**Marty Stuart's Congress of Country Music – Ellis
Theater Renovations**

ADDENDUM NO. 3

FROM: Dryden Architecture + Design

DATE: September 7, 2021

ARCHITECTURAL
CATWALK PLAN

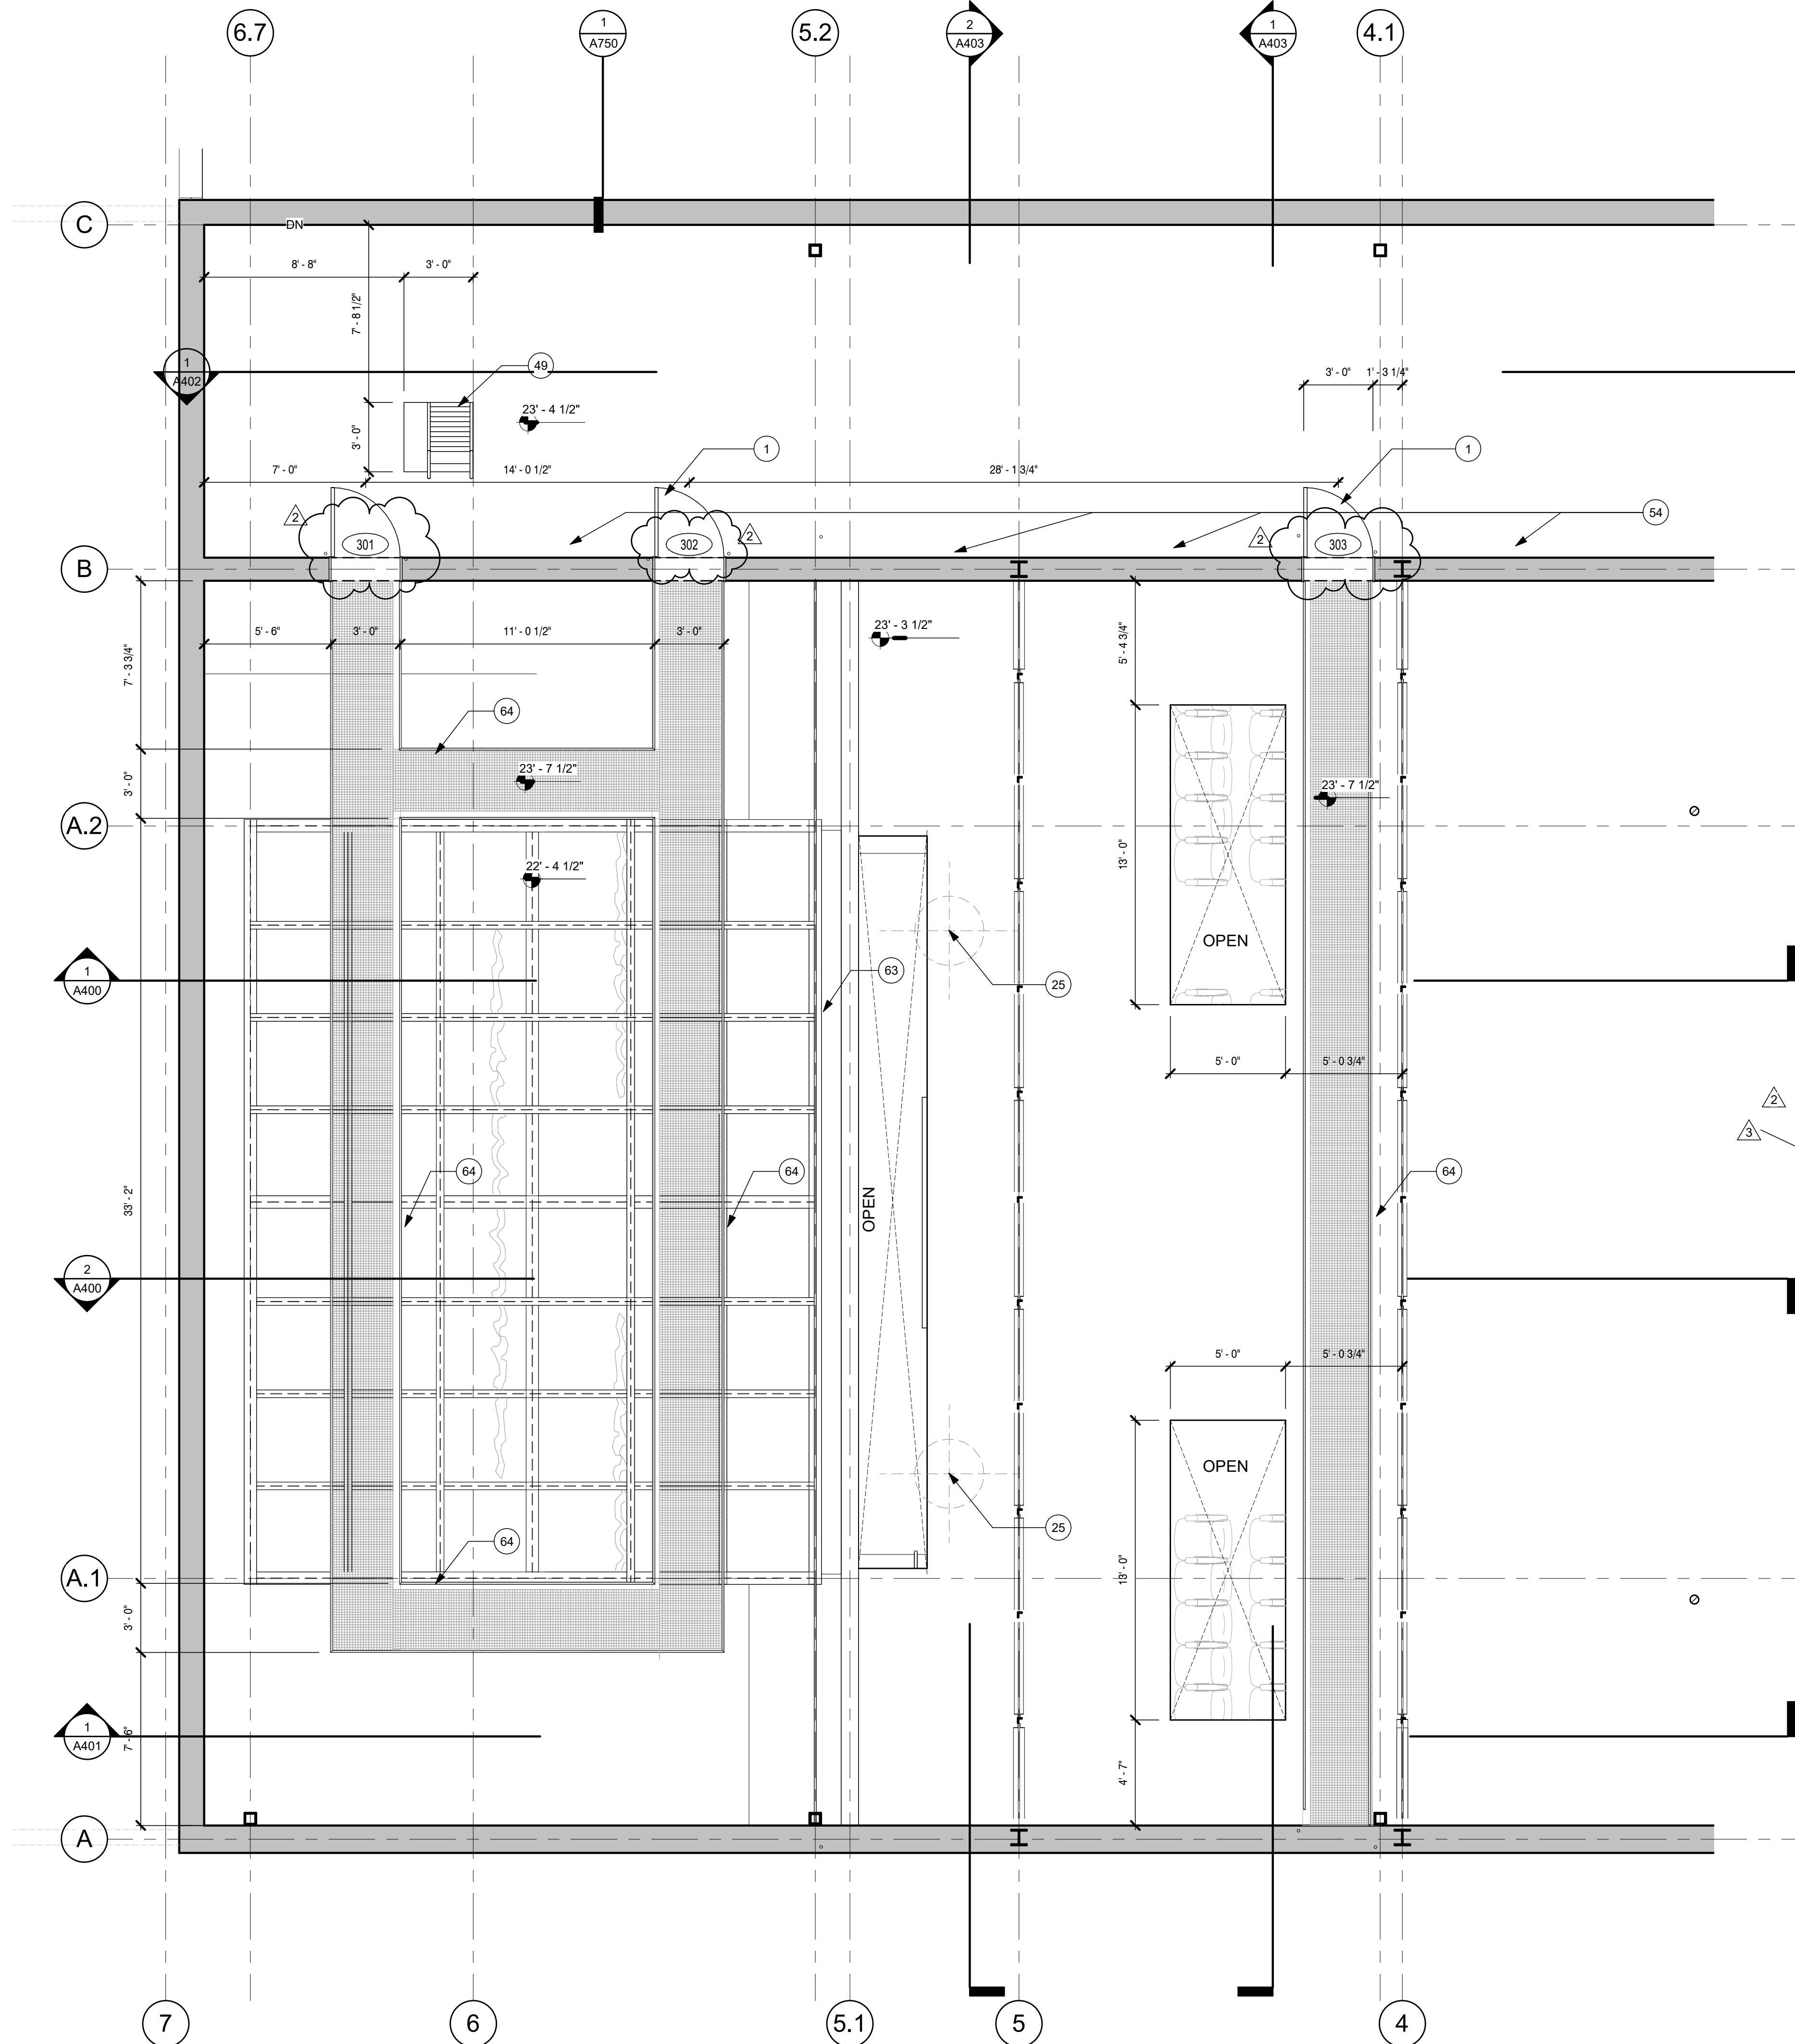
- A. Summary:
 - 1. Performance specifications for engineered catwalks using Unistrut cold-formed adjustable metal framing.
- B. Scope: Catwalks to be 3' wide.
 - 1. Straight run near grid line 4.1 and Box shaped between grids 5.2 and 6.7.
 - 2. Interior application Suspended from roof building joists and joist girders.
 - 3. Catwalks to have the following:
 - Handrails on both sides
 - Toeboard
 - Grating to be galvanized
 - 4. Material finish to be: Unistrut PermaGreen
 - 5. Reference Drawings S300 and S400.
